## S E R V I C E N O T E

HP 8566B Spectrum Analyzer  
 HP 8567A Spectrum Analyzer  
 HP 8568B Spectrum Analyzer  
 HP 85662A IF-Display Section

**Misloaded Capacitor Exposed to 130% of Its Rating**

DATE: 25 May 1990

**Figure 1. Location of A1A10C1 and A1A10C4**

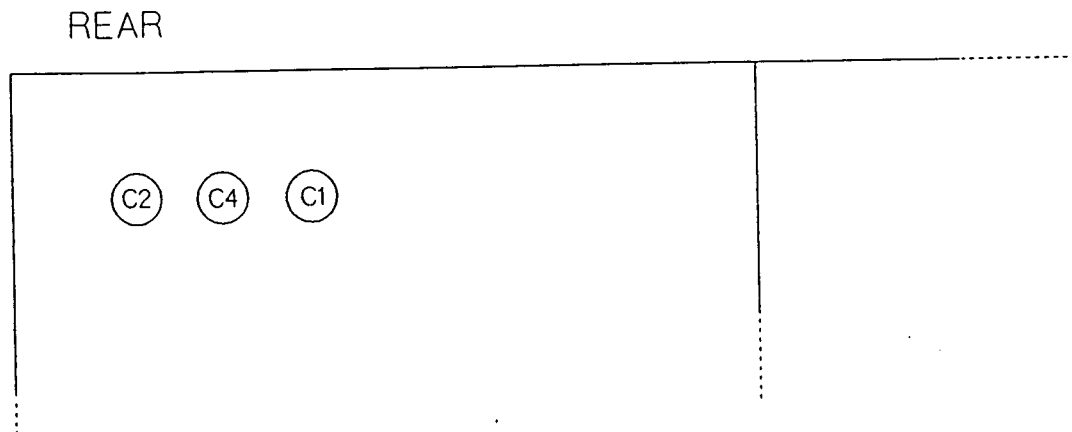
An assembly process variation was discovered that might have resulted in two large electrolytic power supply capacitors being installed in the wrong location in HP 85662A IF-Display Sections within the serial range listed above. When installed in the wrong location, one of the capacitors can be exposed to as much as 130% of its rating. This would probably result in a premature capacitor failure, with possible venting of the capacitor electrolyte onto the bottom of the IF-Display Section. Venting might cause damage to other components and assemblies.

The two capacitors affected are A1A10C1, 22000  $\mu$ F (HP part number 0180-2808), and A1A10C4, 8700  $\mu$ F (HP part number 0180-0453). They are located along the HP 85662A rear frame, behind the CRT. Both capacitors are the same physical size.

1. Remove the power cords and interconnect cables from the rear of the spectrum analyzer.
2. Loosen the lock feet and separate the RF and the IF sections; set the RF section aside.
3. Remove the 2 rear feet near the top of the IF-Display Section.
4. Remove the top cover and check for proper position of the capacitors (A1A10C1 and A1A10C4). See Figure 1.

Any HP 85662A IF-Display Section within the above serial range should be inspected. If capacitors A1A10C1 and A1A10C4 are found to be installed in the wrong location, replace both capacitors with new ones using the following procedure.

8. Remove the 4 screws securing A1A10C1 and A1A10C4 to the motherboard.
9. Remove the existing capacitors and replace with new capacitors, making sure the A1A10C1, 22000  $\mu$ F (HP part number 0180-2808), and A1A10C4, 8700  $\mu$ F (HP part number 0180-0453), are in the correct locations.
10. Reinstall the bracket, top cover, bottom cover, and the 4 rear feet.
11. Mate the IF and RF sections and reconnect cables. No calibration is required.
